New Mexico Oil Conservation Division approval and conditions
listed below are made in accordance with OCD Rule 19.15.7.11
and are in addition to the actions approved by BLM on the
following 3160-4 or 3160-5 form.

PLUG AND ABANDONMENT PROCEDURE

Jicarilla Contract 155 #008

**Re: Permanent Abandonment
Well: Jicarilla Contract 155 No. 008**

Jicarilla Contract 155 #8

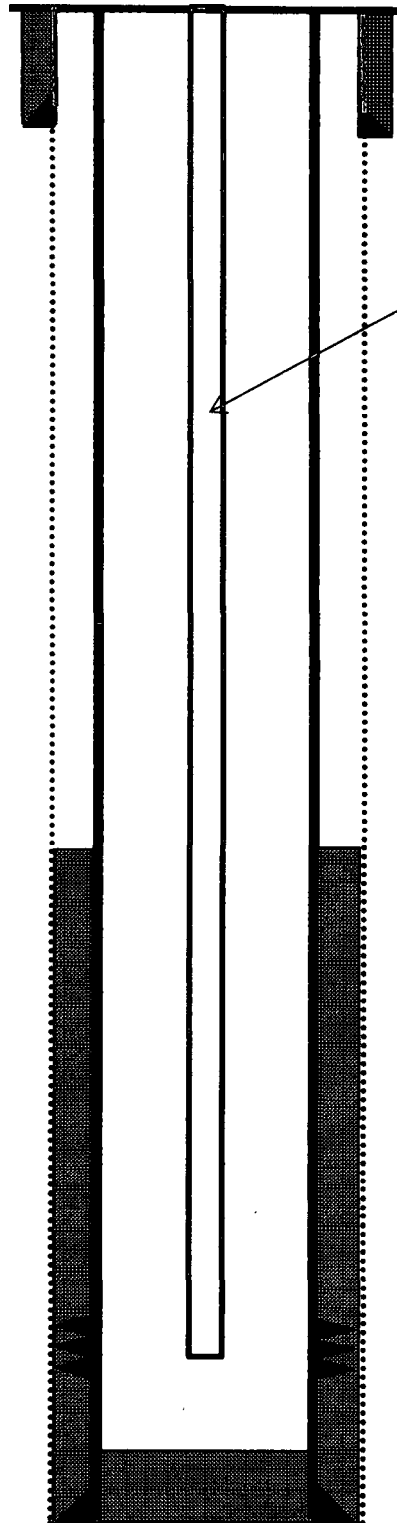
- Notify NMOCD 24hrs prior to beginning operations.
- Extend plug #1 down to 2752 as originally proposed to cover the perforations.
With the BLM conditions this plug will be from 2752'-2162'.
- If there is not cement as shown by CBL above 2162', plug #1 may be required to
be split into separate formation plugs.

- a) Set Plug #1 (2572 - 2162) ft. to cover the Pictured Cliffs perforations and the Fruitland, Kirtland, and Ojo Alamo tops. BLM picks top of Ojo Alamo at 2212 ft.**
- b) Set Plug #2 (880 - 780) ft. inside/outside to cover the Nacimiento top. BLM picks top of Nacimiento at 830 ft.**
